H. B. ROBINSON STEAM ELECTRIC PLANT, UNIT NO. 2  
DOCKET NO. 50-261/LICENSE NO. DPR-23  
RESPONSE TO REQUEST FOR ADDITIONAL INFORMATION REGARDING  
REQUEST FOR EXCEPTION TO LOCATION OF THE TECHNICAL SUPPORT  
CENTER IN THE PROTECTED AREA SUBMITTED FEBRUARY 24, 1995

ENCLOSURE  
RESPONSE TO REQUEST FOR ADDITIONAL INFORMATION REGARDING  
REQUEST FOR EXCEPTION TO LOCATION OF THE TECHNICAL SUPPORT  
CENTER IN THE PROTECTED AREA SUBMITTED FEBRUARY 24, 1995

H. B. ROBINSON PLANT

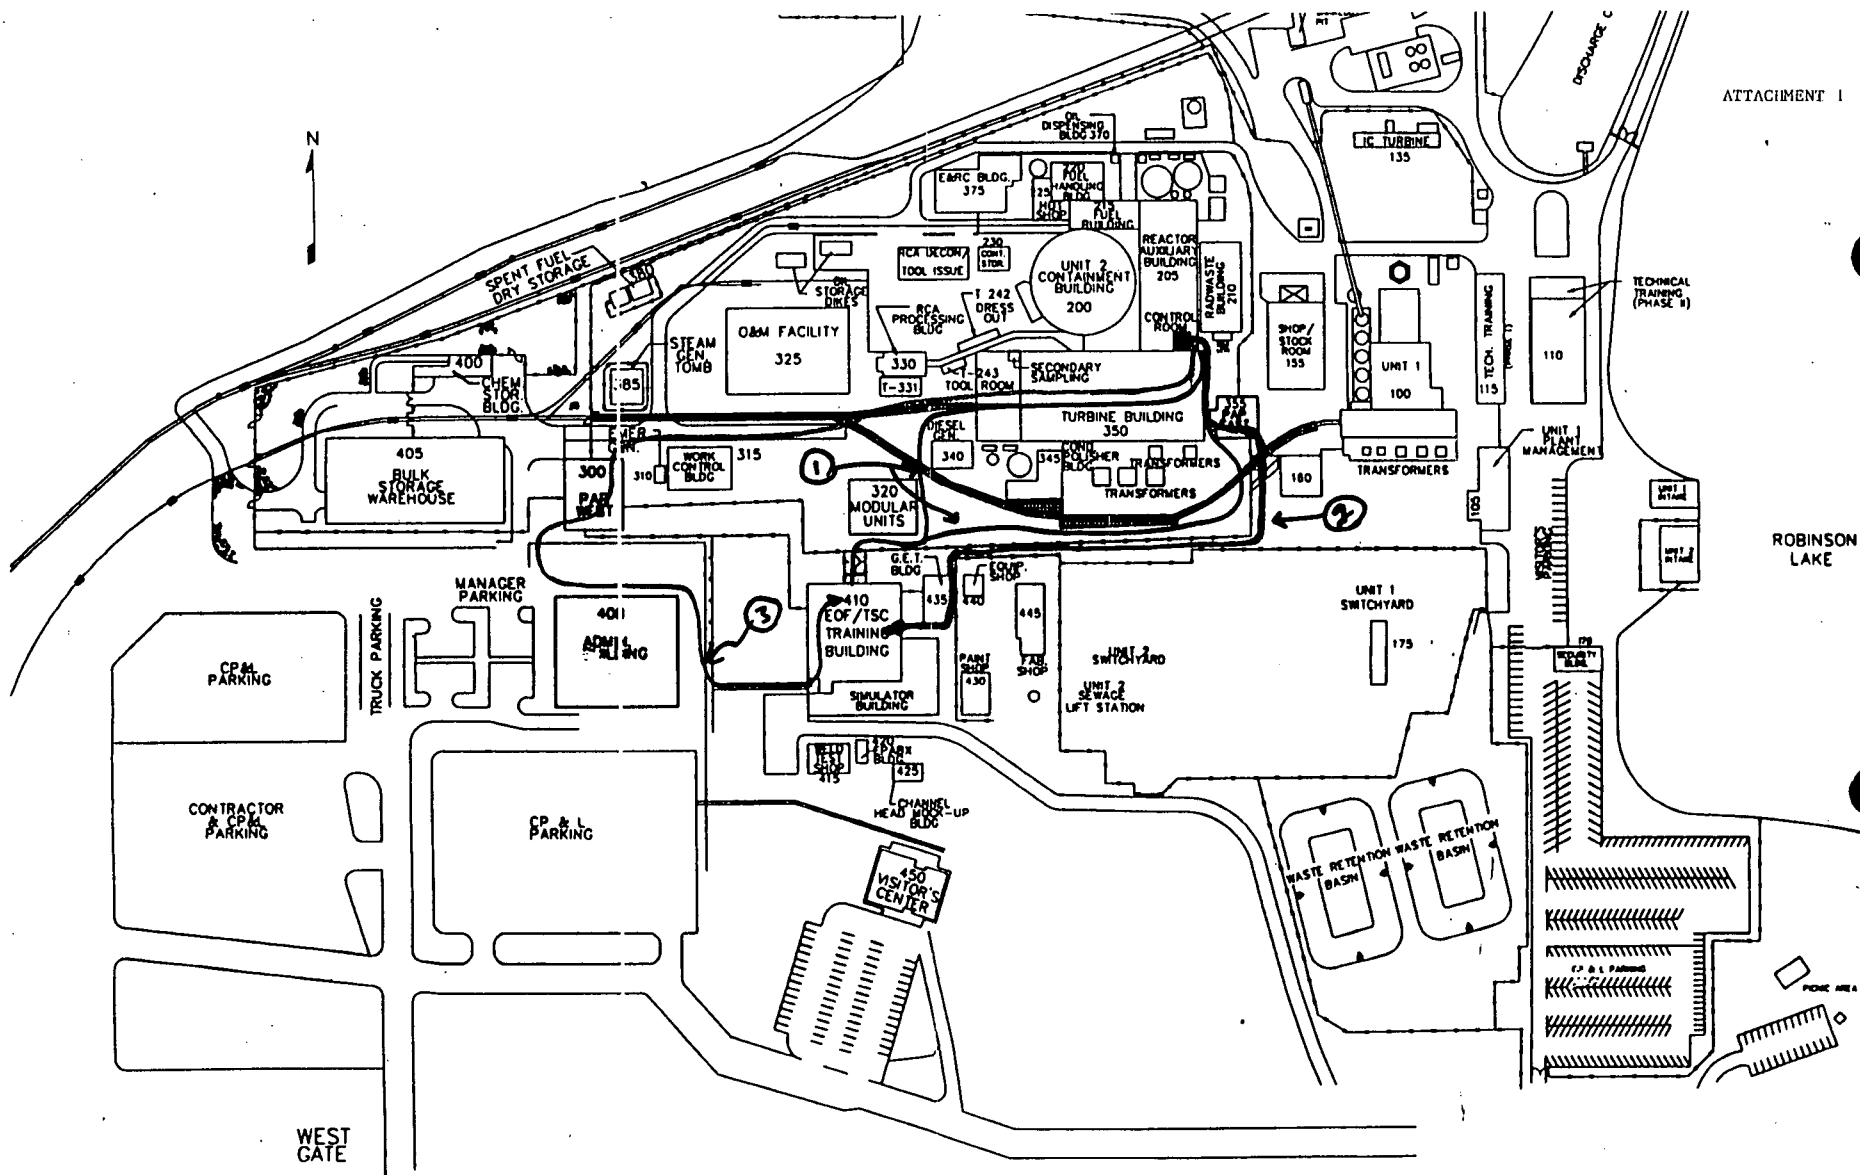
"Describe the route(s) of travel and associated time(s) of transit between the Technical Support Center (TSC) and the control room."

There are 3 potential routes for travel from the control room to the TSC if the TSC is not incorporated into the protected area.

- 1) The current route would be maintained from the control room through, or around, the Turbine Building, behind Building 320 and into the TSC. This accounts for the ability of personnel travelling between the control room and the TSC to pass through the gate in the Protected Area boundary fence during emergency conditions. The travel time for this route is approximately 3.5 minutes.

- 2) A route would be available from the control room exiting the protected area through the East Personnel Access Portal (PAP), along the protected area fence past the General Employee Training Building, and in the east door of the Emergency Operations Facility (EOF)/TSC Training Building. The travel time for this route is approximately 5.0 minutes.

- 3) An additional route would be available from the control room through the Turbine Building, exiting the protected area through the West PAP, along the Administration Building and in the west door of the EOF/TSC Training Building. The travel time for this route is approximately 7.5 minutes.

These routes are shown on Attachment 1.
